# **Recommendations for Critical Flaw Size Calculations**

***(in Wolf Creek Advanced FEA Project)***

# Summary of Key Issues from [1]

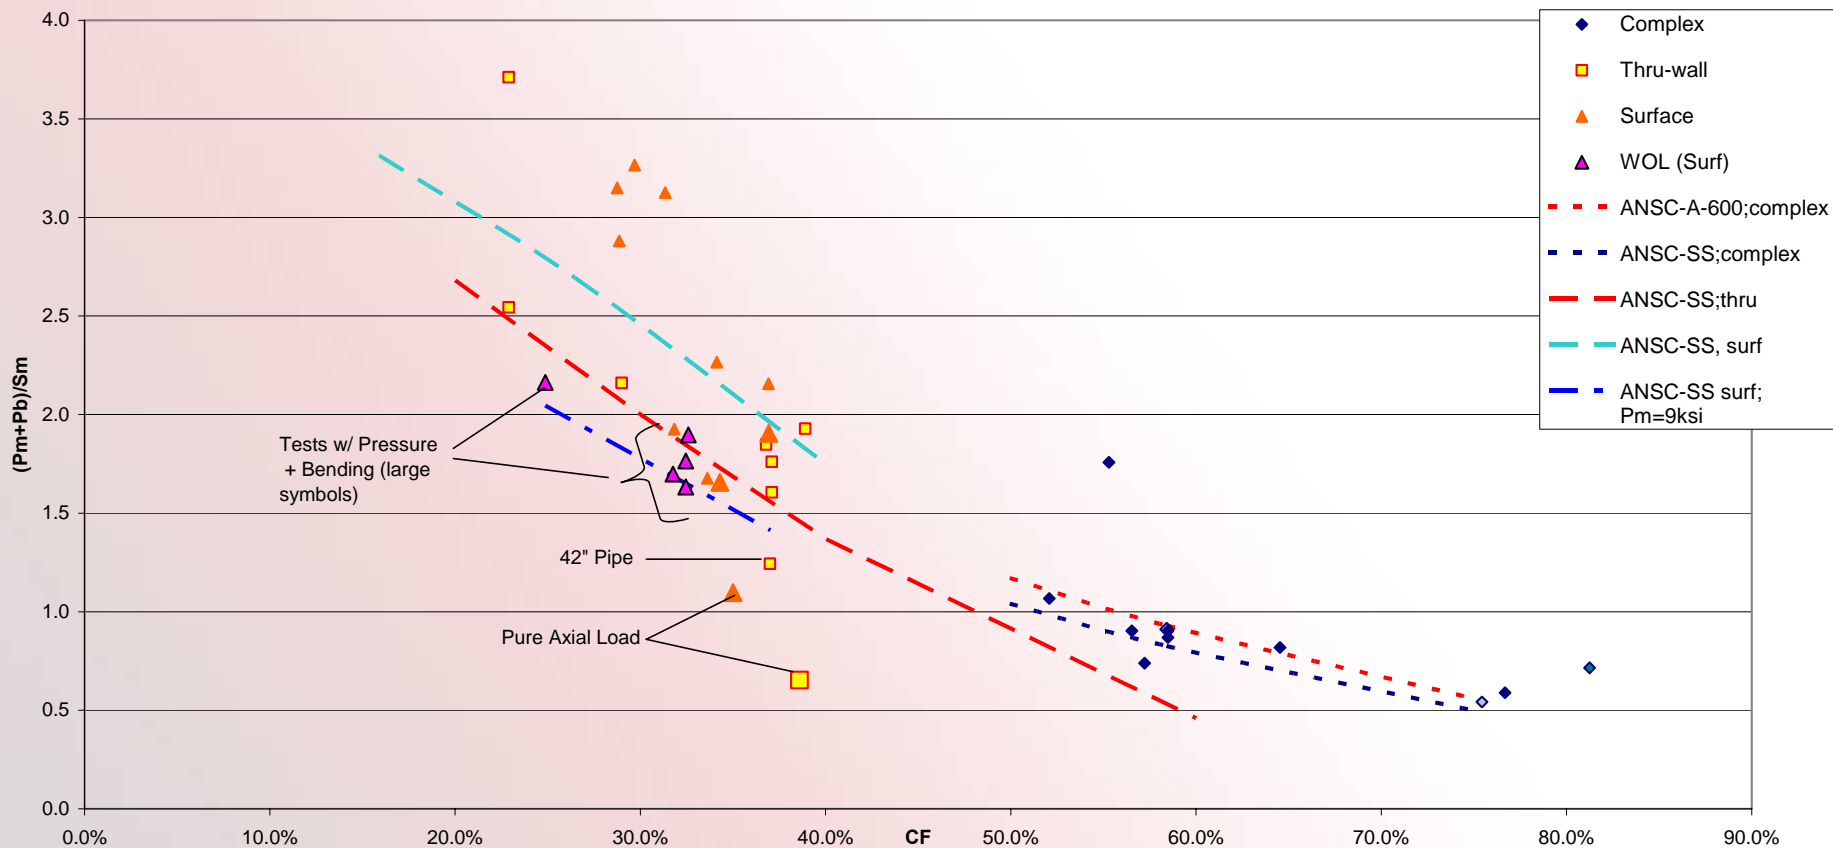
- **EPFM vs. Limit Load**
- **Material Properties for Use in Evaluation**
- **Inclusion of Secondary Stresses**

# DPZP Screening Criteria Adapted to Complex Cracks

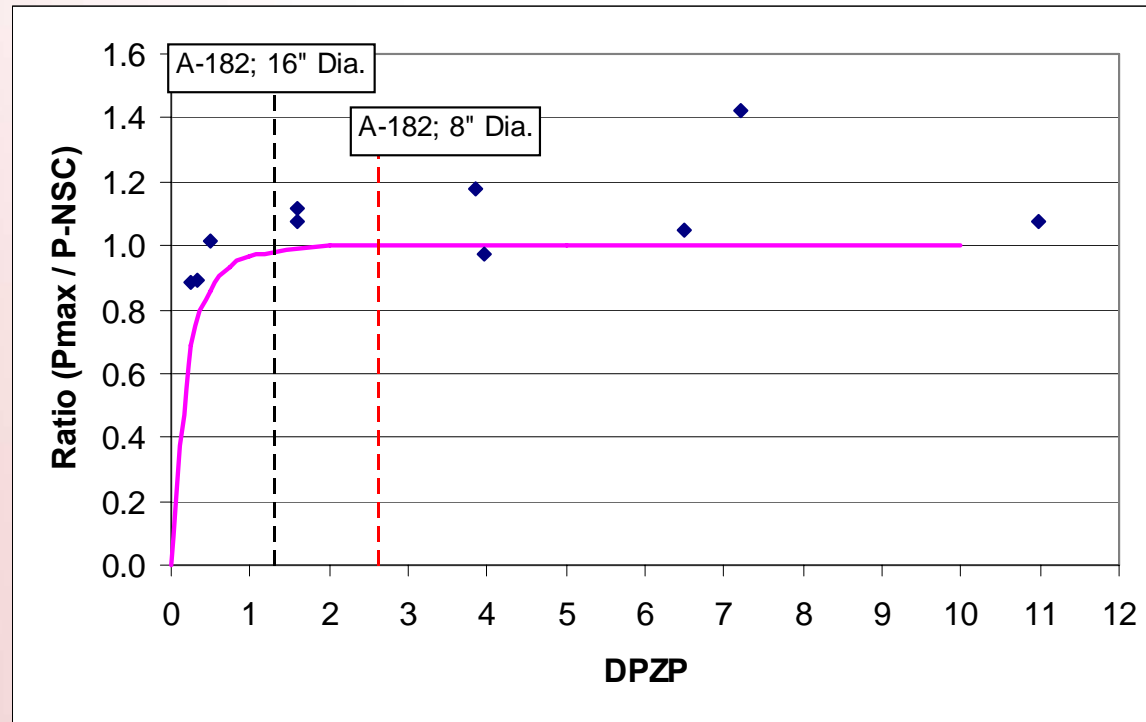
- Plot of data from Battelle/NRC Full Scale Pipe Tests on SS and A-600 indicates that Limit Load (ANSC) works well for all flaw types tested
- Comparison of Fracture Toughness (J-R Curves) indicates Alloy 182 not significantly less tough than tested materials
- DPZP screening criteria [2] adapted to complex crack tests gives reasonable results
  - ◆ Can be used to screen current analyses of A-182 for appropriate analysis type

- **Limit Load vs. EPFM - Apply DPZP Screening Criteria**
  - ◆ For  $DPZP > 1.0$ , use limit load (ANSC for actual flaw shape)
  - ◆ For  $DPZP < 1.0$ , use limit load with Wilkowski Z-Factor Correction
- **Material Properties**
  - ◆ Use SS Base Metal Tensile Properties (Flow Stress, Stress-Strain Curve)
- **Secondary Stresses**
  - ◆ Overly Conservative to Include Full Value of Large Stratification Moments in Surge Nozzle Limit Load Evaluations
  - ◆ Include Piping Geometry of Typical Plant(s) to Determine Effect of Secondary Stress on J-T Analyses

# Schematic of Compliant Load Complex Crack Pipe Test [4]

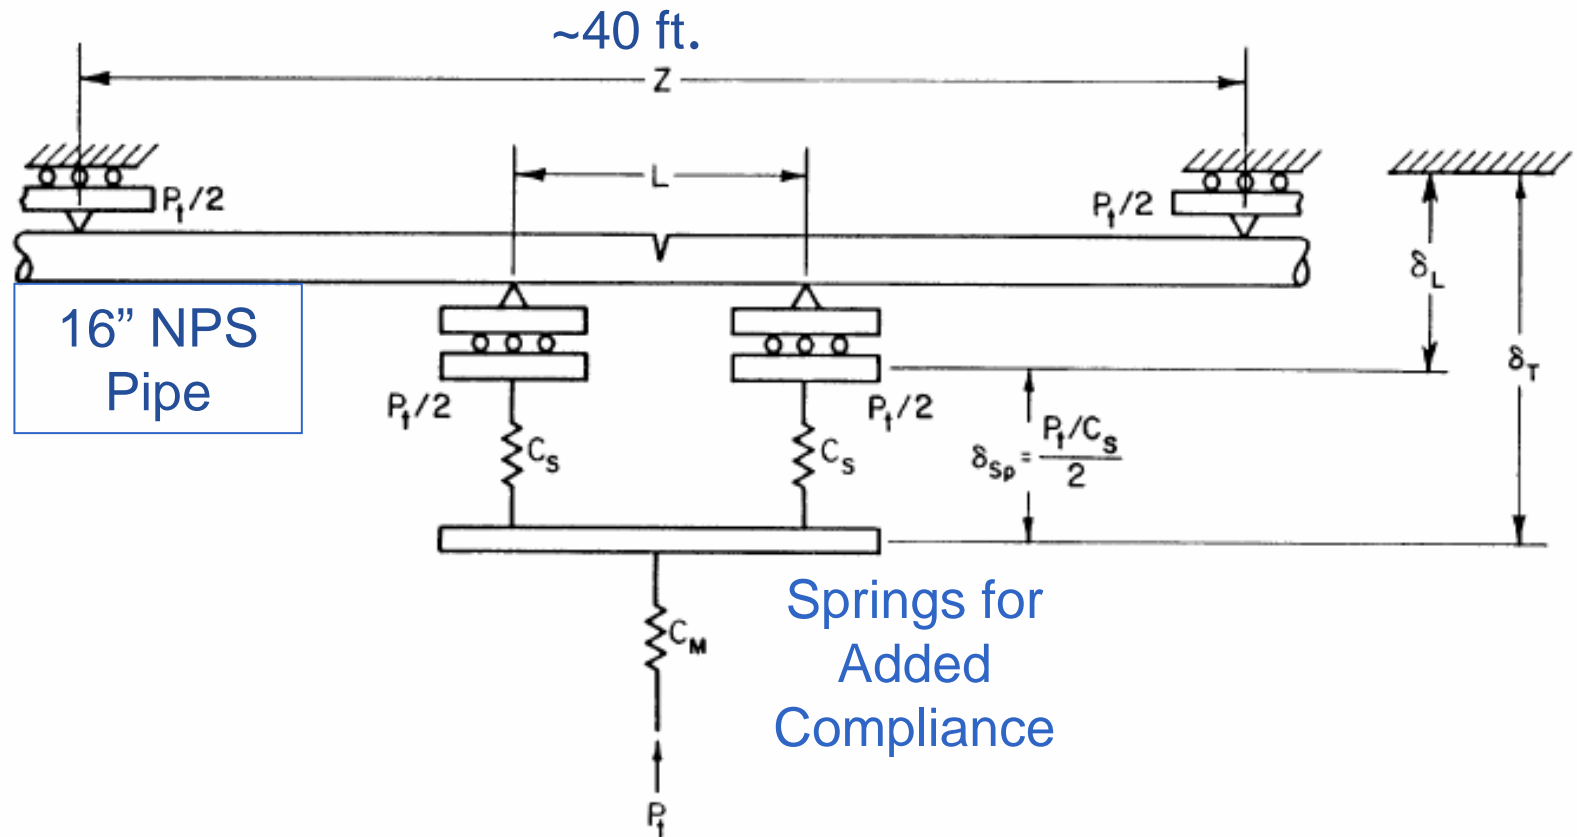
- **Dynamic tests cited in [1] as reason for including secondary stresses not compelling**
- **Static tests with large complex cracks indicate large displacements required prior to crack instability**
  - ◆ **many times larger than expected displacements due to thermal loadings in plants, including stratification**
